No: 24-040

DAUPHIN COUNTY SUBDIVISION/LAND DEVELOPMENT REVIEW REPORT

Plat TitleCreekview Lawn & Landscapes

LAYOUT PLAN

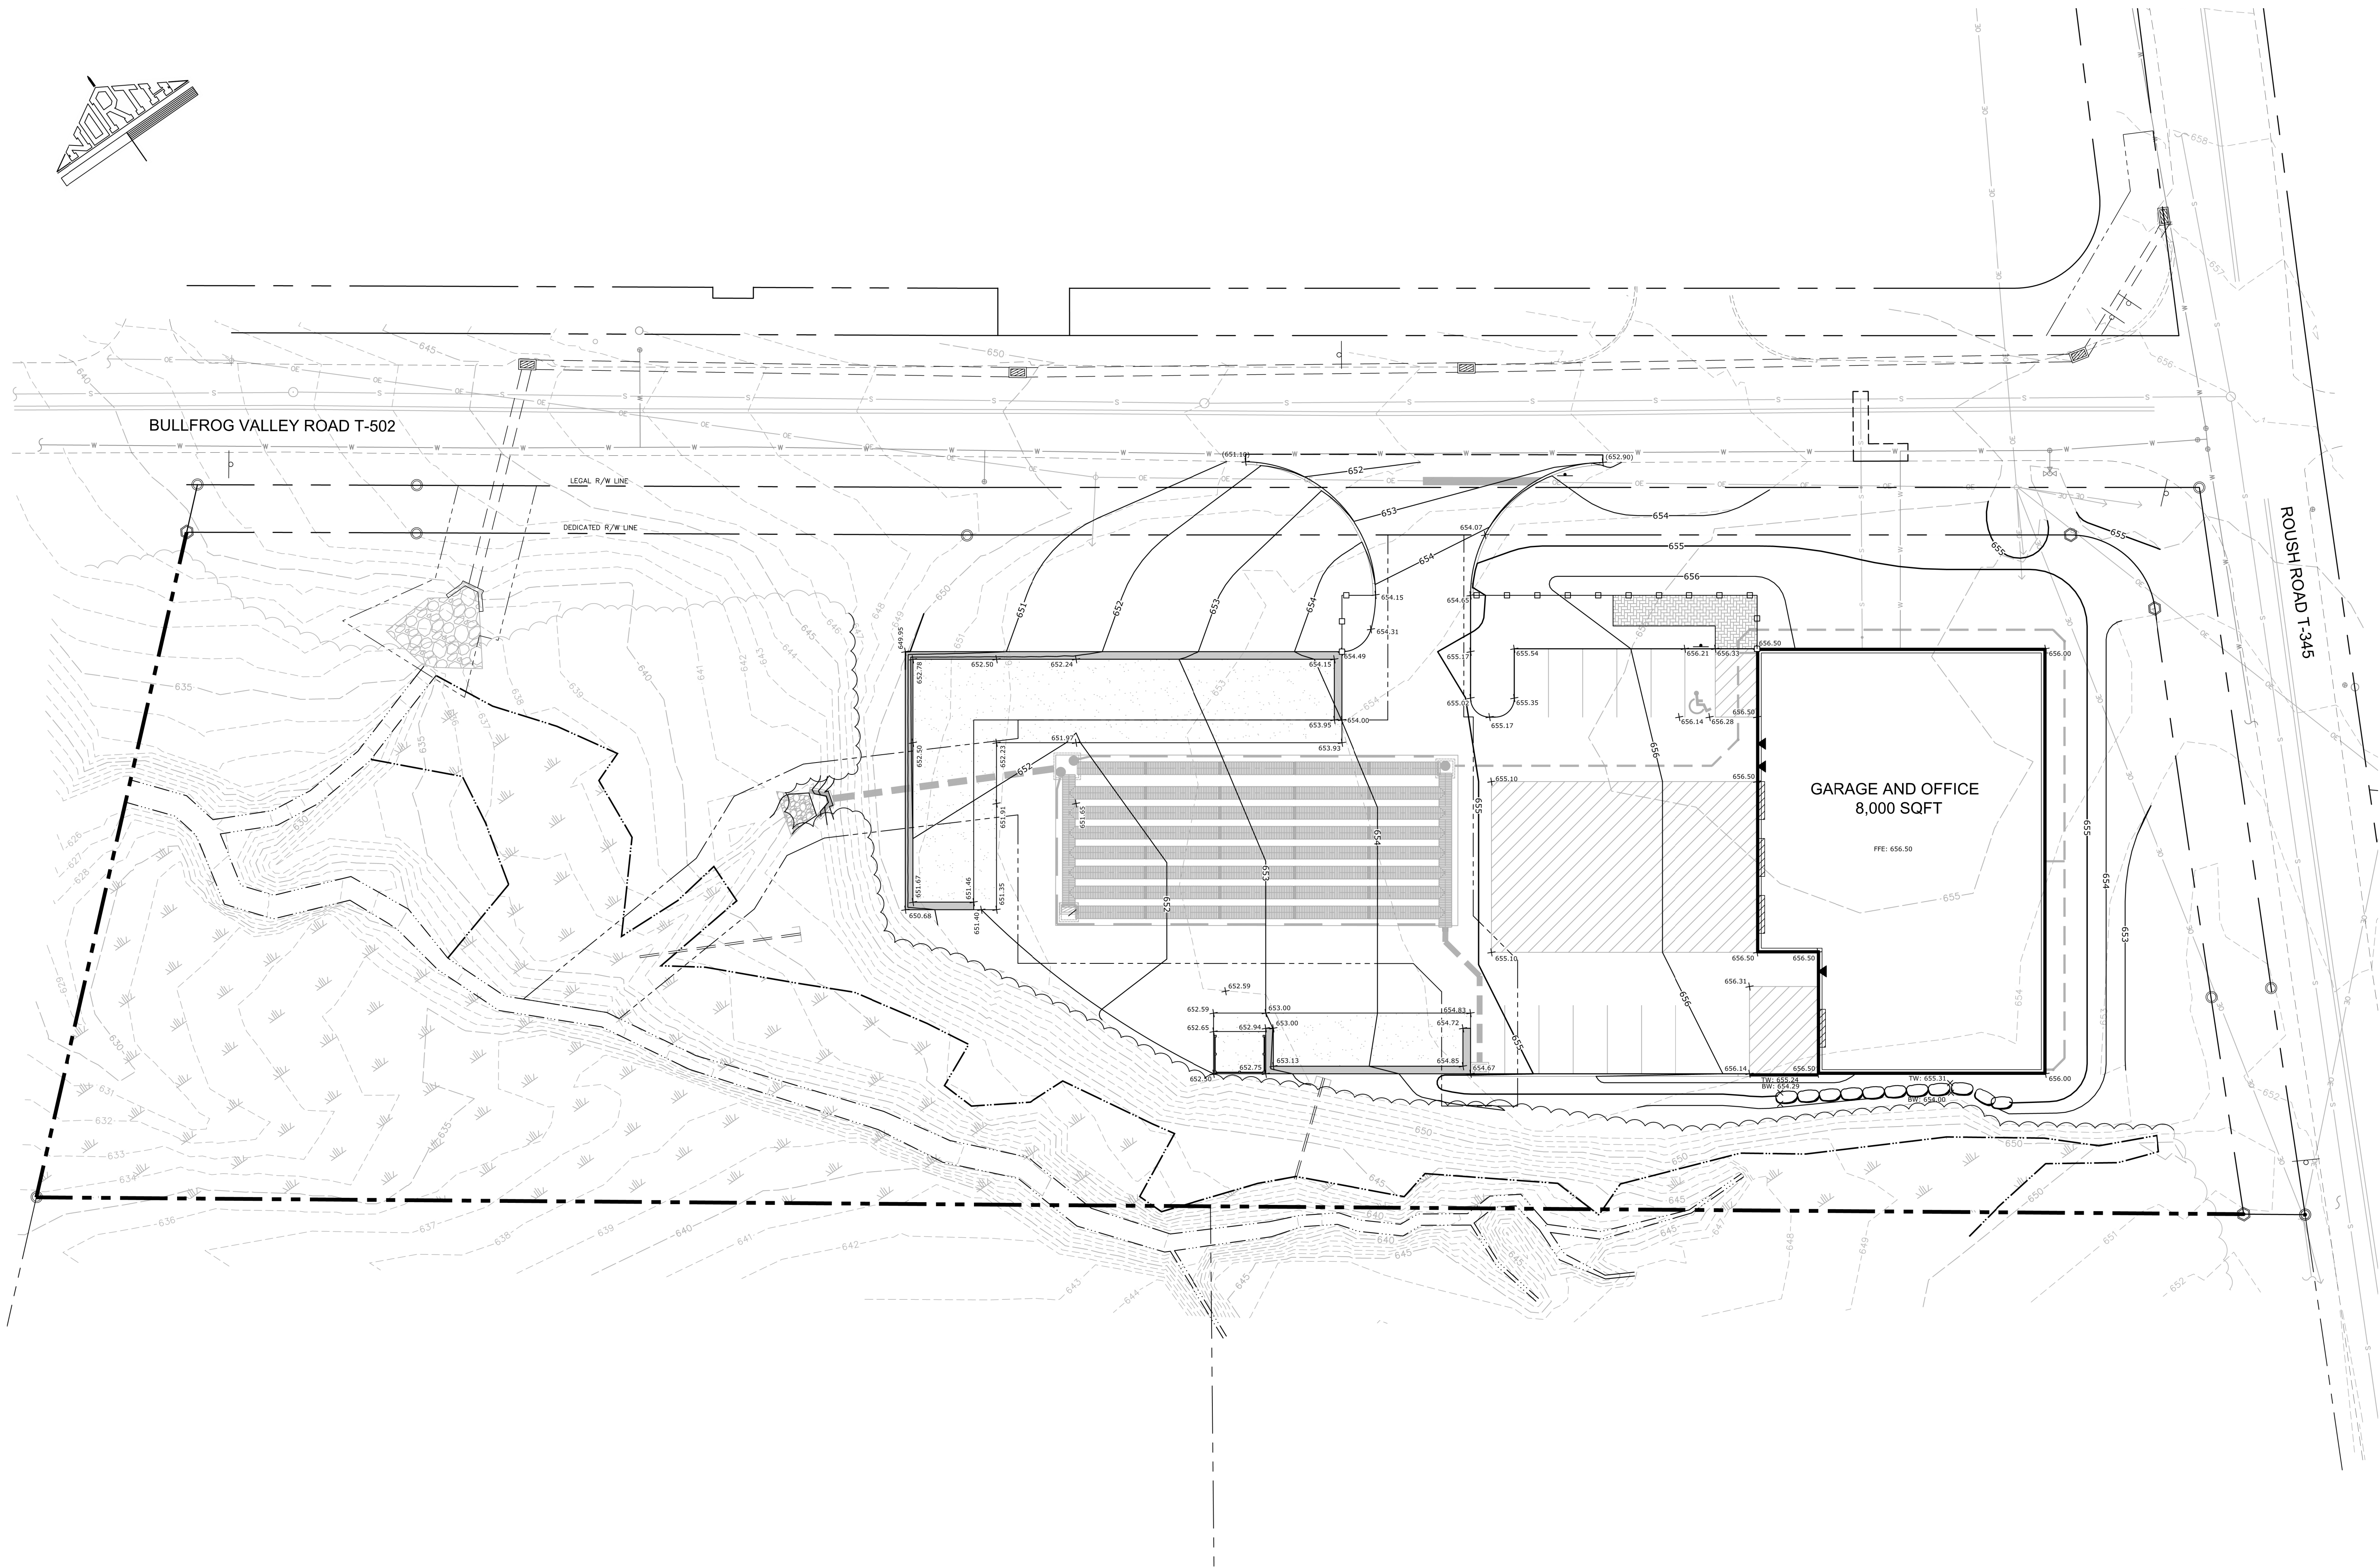
4. Verify separation distance between driveways (with Mary’s Fitness) is adequate/safe.
